STAFF RECOMMENDATION

813 Boscobel Street

April 20, 2016

Application: New construction-addition; Partial demolition

1 SITE PLAN
1/16" = 1'-0"

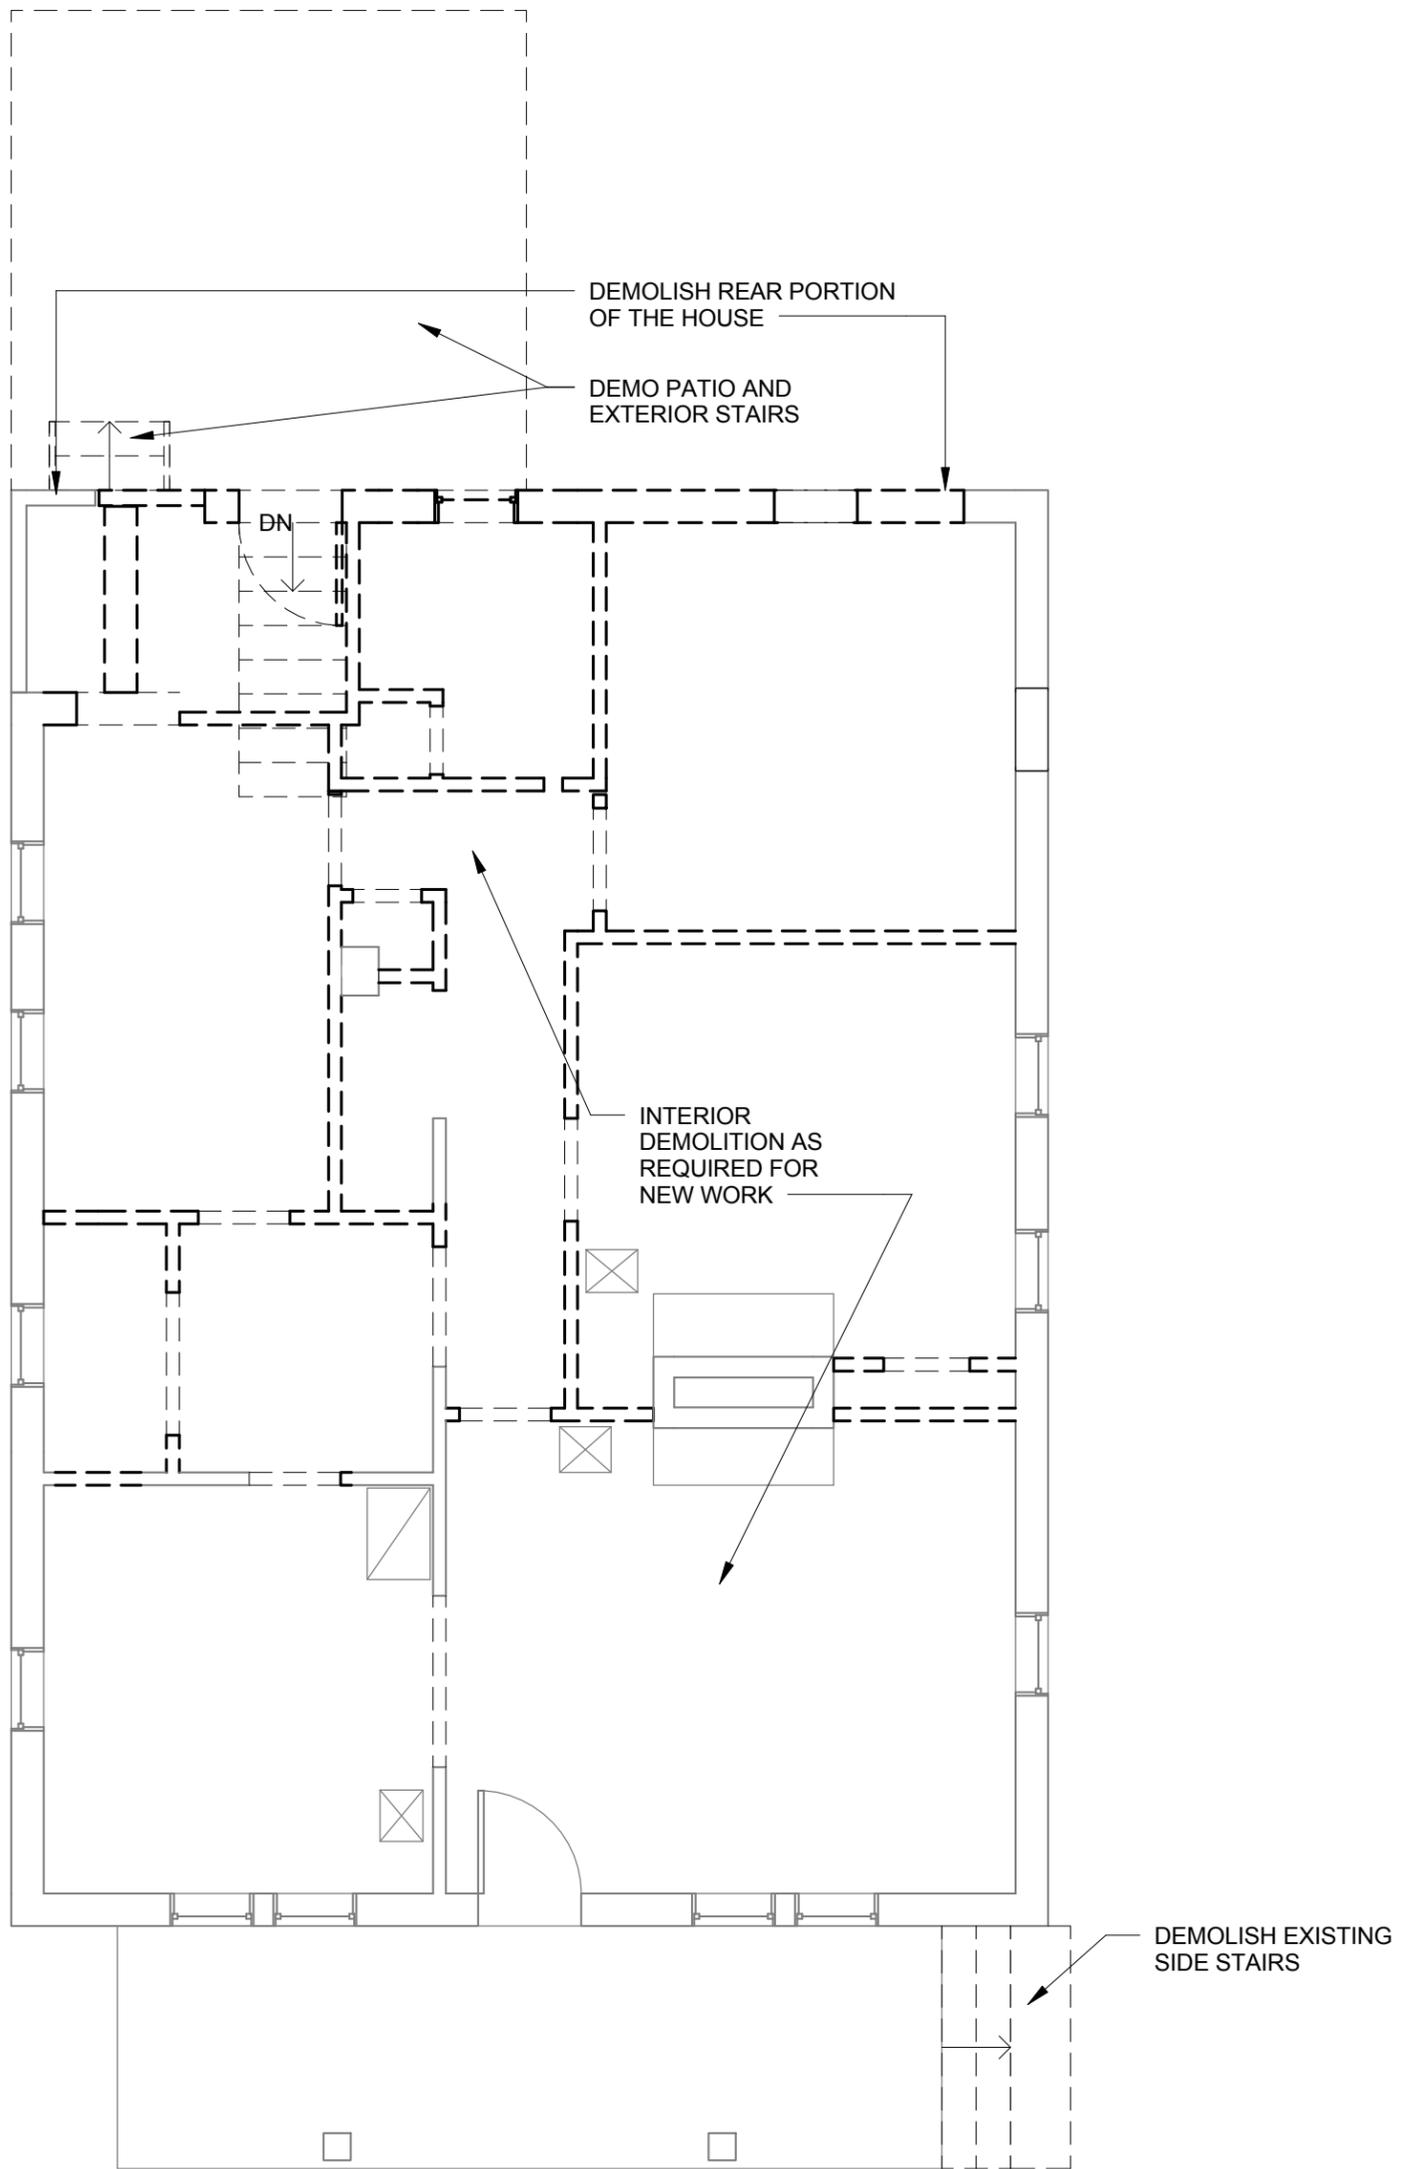
Design, Location & Removability: The proposed addition is located at the rear and is inset from both rear corners by two feet (2'). The addition then goes back on both sides by five feet, six inches (5' 6") before coming back out twelve feet (12') on the right side and one foot (1') on the left side. On the right side, the addition is ten feet (10') wider than the existing house. The addition is no wider than the existing house on the left side. The addition meets the requirement of the design guidelines for additions to be inset at least two feet (2') for two-story additions. Also, it is appropriate for the addition to go wider than the existing house given that the house is thirty feet (30') wide at the front and is shifted to the left side of the lot. Staff finds the location of the proposed addition to meet sections III.B.1 of the design guidelines.

Setback: The side setbacks of the addition will be six feet (6') on the left side, and nine feet (9') on the right side. The rear wall of the addition will be approximately sixty-eight feet (68') from the rear property line. The setbacks for the addition meet the bulk zoning standards and are consistent with the historic context of the surrounding area. Therefore, staff finds that the project meets section III.B.2.a for setbacks.

① FIRST FLOOR DEMOLITION PLAN
3/16" = 1'-0"

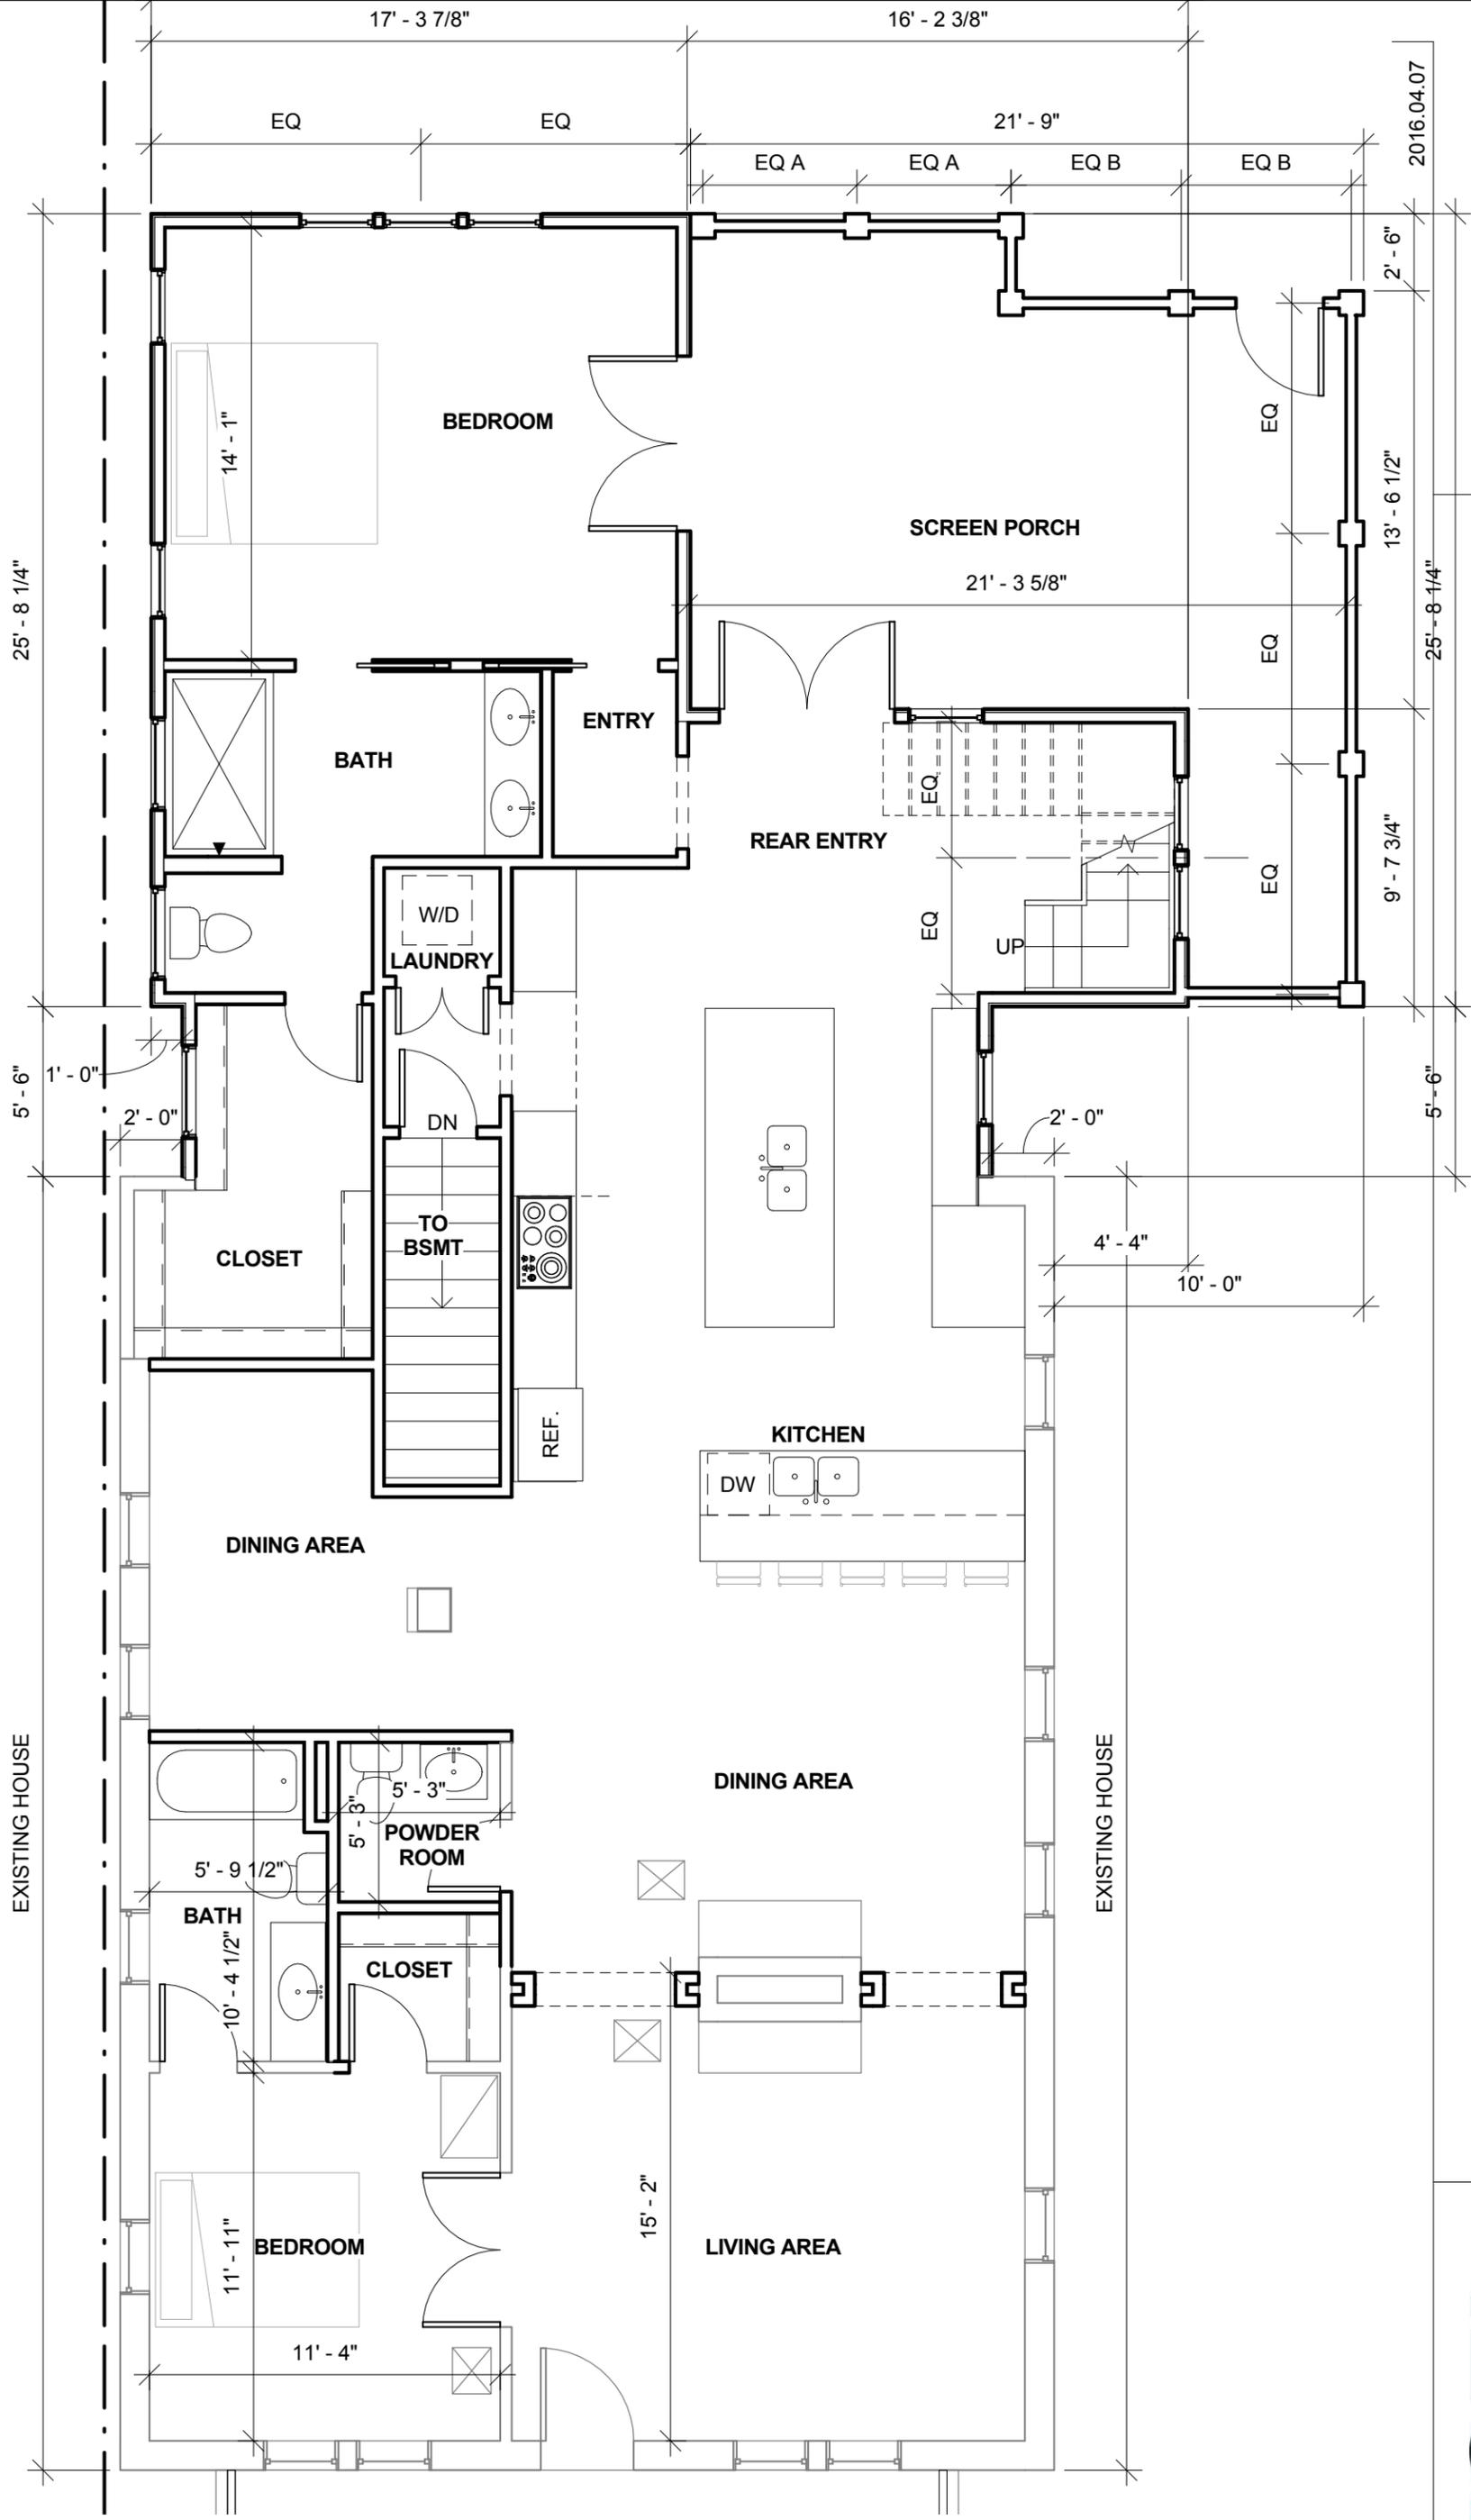
Demolition: Demolition is proposed for a portion of the rear wall of the house. However, the plan proposes to keep the rear corners intact. The existing rear patio and exterior stairs will also be demolished. No changes to the dimension and design of the existing openings are proposed. Staff finds the proposed demolition of the rear wall is appropriate as it is a partial demolition which would allow for an addition and does not propose demolition of a major portion or a character defining portion of the building.

1 ROOF PLAN
3/16" = 1'-0"

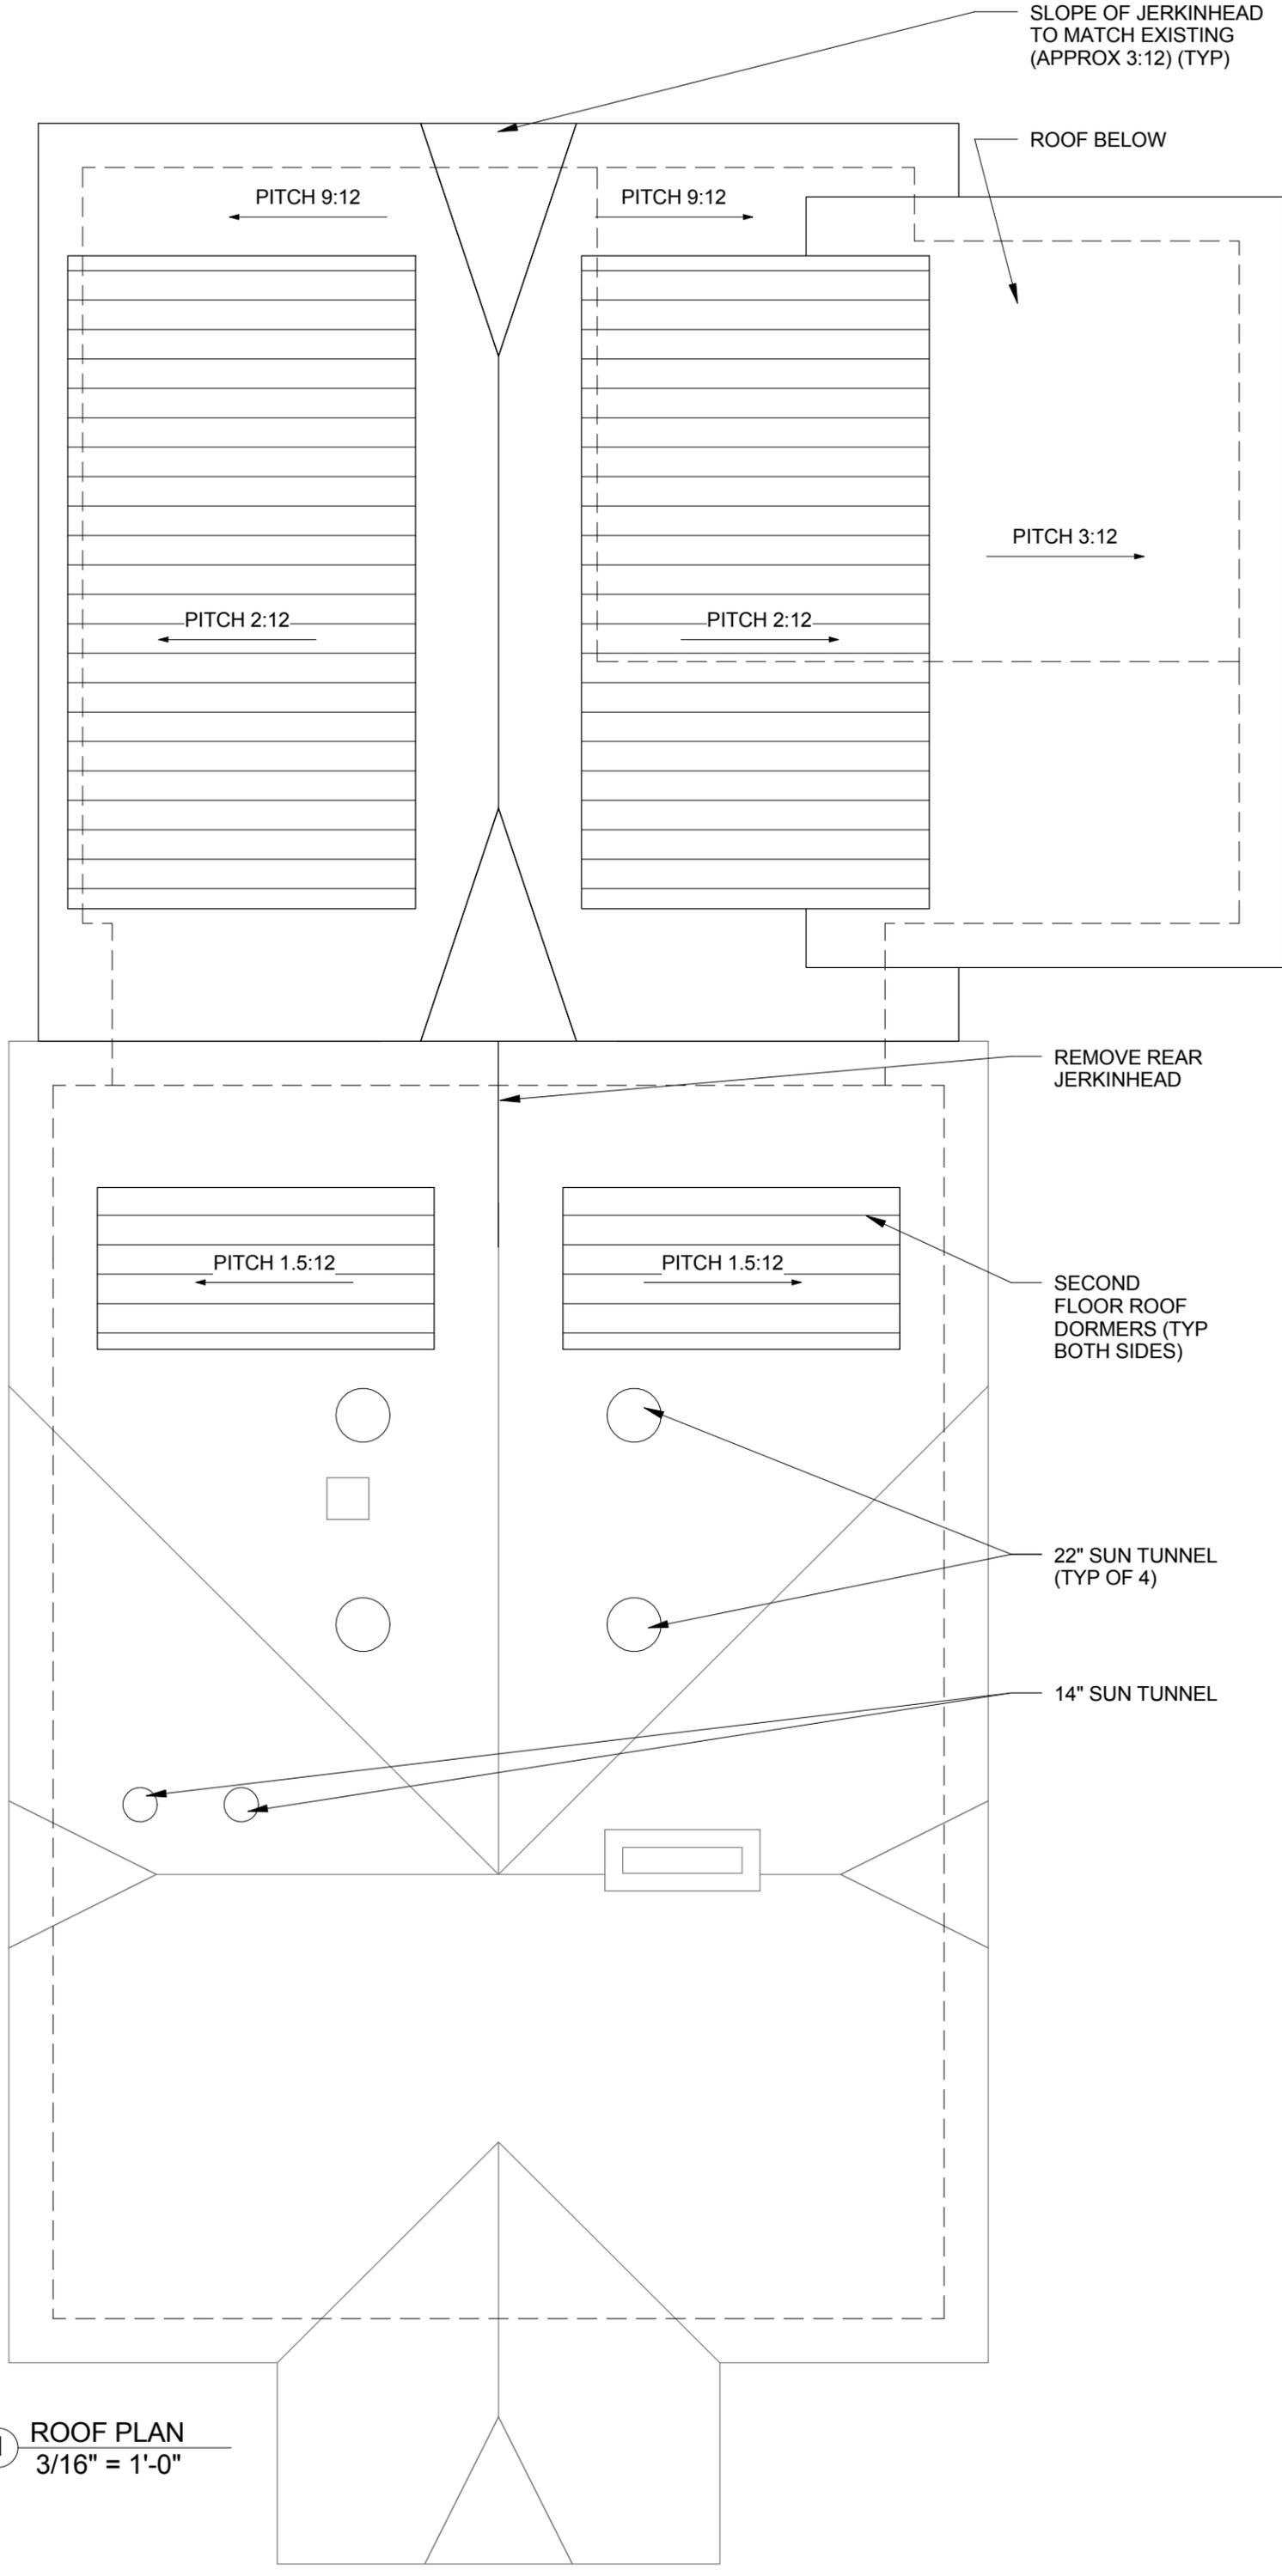
Roof form: The existing house has a clipped cross-gabled roof form, and the roof of the addition is also clipped with a 9:12 roof pitch that complements that of the historic house.

The addition proposes a side shed dormer on both sides of the existing house with pitches of 1.5:12. The design guidelines for the Edgefield state that dormers generally should not be introduced where none existed originally. Side dormers are routinely allowed in neighborhood conservation zoning overlays if they are of a similar scale and size to historic dormers on the building or on buildings of a similar form and massing, but not in historic overlays like this one. Because the proposed dormers are located on a secondary roof form of the historic building, staff finds that the introduction of dormers could meet the design guidelines in this case as they are appropriately scaled and do not tie into the primary roof form. As proposed, the side dormers are approximately five feet (5') wide, sit below the ridge by two feet (2') and sits back from the wall below by two feet (2').

As the roof form on the addition is compatible with the historic house, Staff finds that, with the conditions proposed, the project can meet section III.B.d of the design guidelines.
